SUNDRY NOTICES AND REPORTS ON WELLS

Osage Federal #7

## PROPOSED PLUGGING PROCEDURE

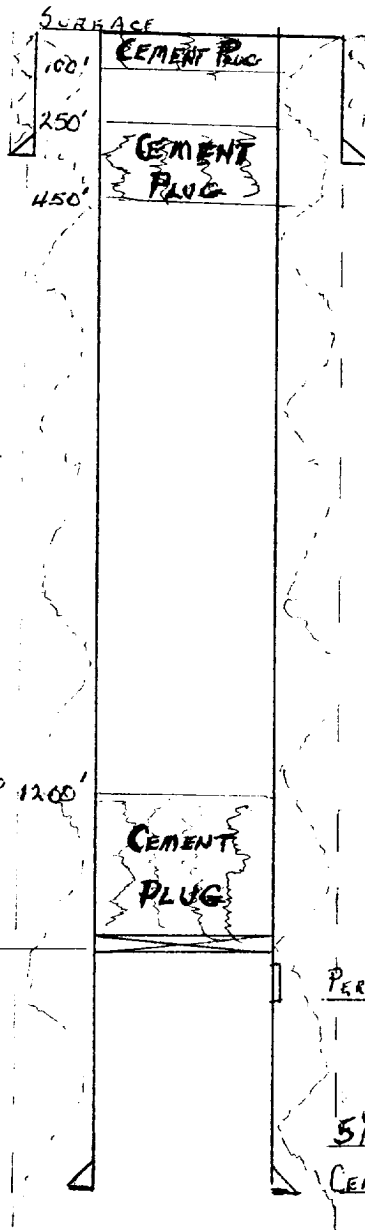
See attached. Also tag plug across 13 $\frac{3}{8}$ " csg shoe.
